Spaces for People

Scheme Review Form

Location	Original justification
Morningside Town Centre	To provide safe space for pedestrians to walk, exercise and access local shops. To provide safe cycling routes and prioritise public transport as an alternative to driving.

1. Assess if footway widening could be installed on the South side of Chamberlain Road going around the corner by the Eric Liddle Centre.
2. *Location 35E2 (Morningside Road east):*

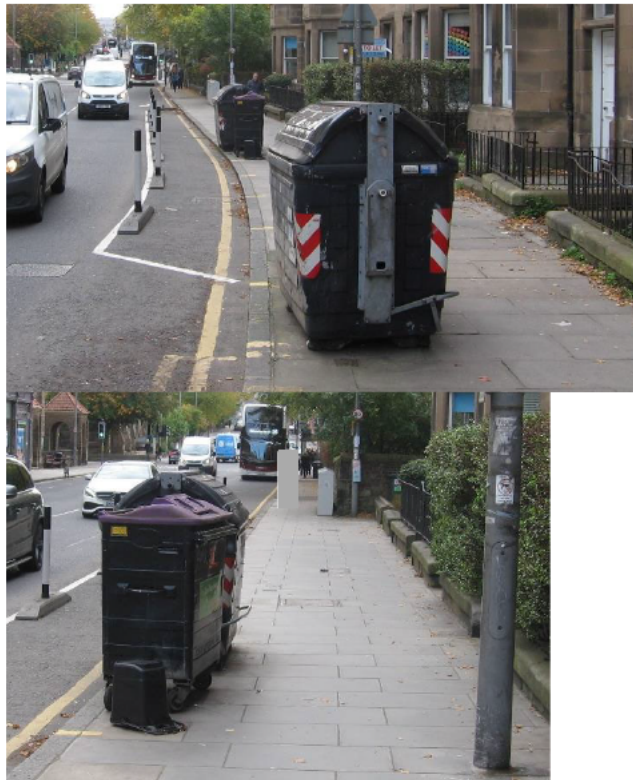
The pavement here is only 2.05m wide (ie significantly less than the SDG 'absolute minimum' of 2.5m) and the Clear Walking Zone is just 1.7m in places – therefore the additional 0.95m SfP space is most welcome.

However, the safety of this section is potentially compromised by the gap at the start of the space and the absence of a pedestrian logo marking on the carriageway – these may encourage some cyclists to use the space when the main carriageway is heavily congested with vehicles.

Recommendation: install a short concrete block at the start of the section and paint a pedestrian logo on the lane immediately behind it.

THE ABOVE WAS RAISED IN THE RSA STAGE 3 – A CYCLE LOGO WITH A DIRECTIONAL ARROW WILL BE INSTALLED TO DIRECT CYCLISTS INTO RUNNING LANE.

Location 22NE1 (Holy Corner north east):

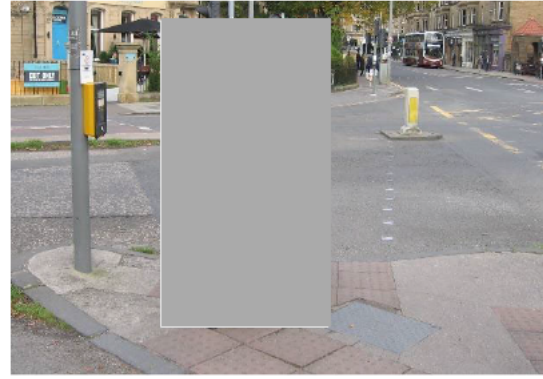
The pavement here is only 2.8m wide (ie less than the SDG 'general minimum' of 3m), and the Clear Walking Zone is just 1.8m.

There are long waits for the Green Man phase, during which large numbers of pedestrians can congregate in a way where it is impossible to maintain social distancing.

Recommendation: in the short term, increase the frequency of the Green Man phase.

Location 23E2 (Morningside Road east):

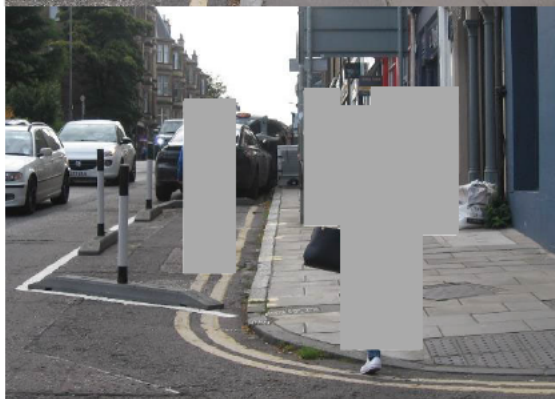
The pavement width here is only 1.9m (ie less than the SDG 'absolute minimum' of 2m), and the parking ticket machine reduces the Clear Walking Zone to just 1.5m.

Recommendation: create a SfP space for walking between the Eric Liddell Centre southern entrance (as in the Location 23E1 photo) and the Greenhill Park junction.

Location 27W (Morningside Road west):

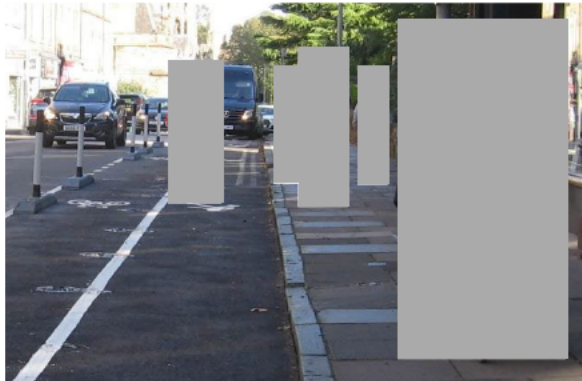
The pavement proper here is only 2.6m wide, and due to the depth of goods on display here, the Clear Walking Zone is only 1.2m in places (ie significantly less than the SDG

Recommendation: retain the SfP space, and in the longer term permanently widen the pavement proper to create a continuous one-level space. Encourage the shop owner to convert his frontage to create street access to goods on display without encroaching on the pavement, as in the example on Home Street – or that on Bruntsfield Place (west side), as shown below.

Location 34W (Morningside Road west):

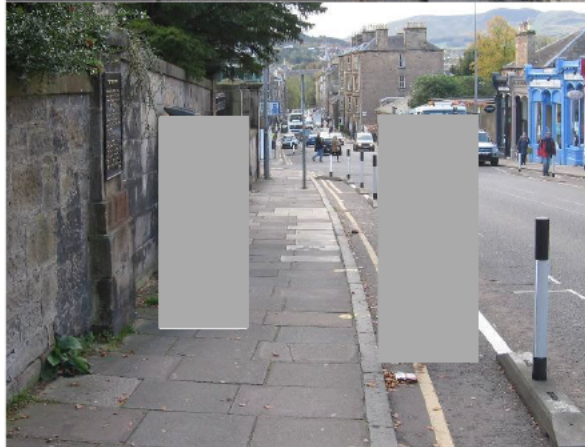
This one of the worst untreated pedestrian pinchpoints on the entire corridor. The pavement here is only 1.4m wide (ie substantially less than the SDG 'absolute minimum' of 2.5m), with vehicular traffic passing (sometimes at speed) less than a metre away from pedestrians. The problem is compounded when people are queuing outside the Shelter shop (right photo). Immediately beyond Shelter, the junction with Abbotsford Park can be difficult for pedestrians to cross, with the eastbound lane of Abbotsford Park 'sweetened' to enable vehicles to turn left on to Morningside Road without stopping.

Urgently review short to medium-term options to create more pedestrian space at a location where the pavement width is severely sub-standard.

In the short-term, reduce the crossing width with concrete blocks (on the north side of Abbotsford Park) as used elsewhere in the project, and in the longer-term create a continuous pavement across Abbotsford Park.

Location 39W (Morningside Road west):

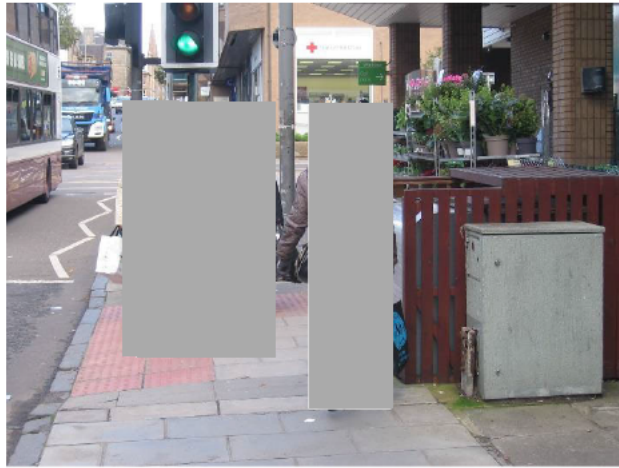
This is one of the most valuable improvements made by the SfP project along the A702 corridor. The pavement proper is only 2.15m wide (ie significantly less than the SDG 2.5m 'absolute minimum') and therefore the additional space is very welcome for pedestrians.

Recommendation: retain the SfP space, and in the longer term permanently widen the pavement proper to create a continuous one-level space.

Location 42W (Morningside Road west):

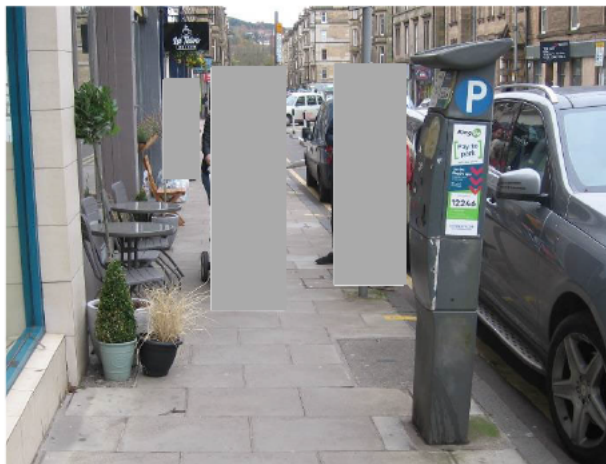
This is one of the most valuable improvements made by the SfP project along the A702 corridor. The pavement proper is only 1.25m wide (ie half the SDG 2.5m 'absolute minimum') and therefore the additional 1.75m SfP space is very welcome, taking the entire pedestrian space width up to the 3m SDG 'general minimum', albeit split in two levels.

Recommendation: retain the SfP space, and in the longer term permanently widen the pavement proper to create a continuous one-level space.
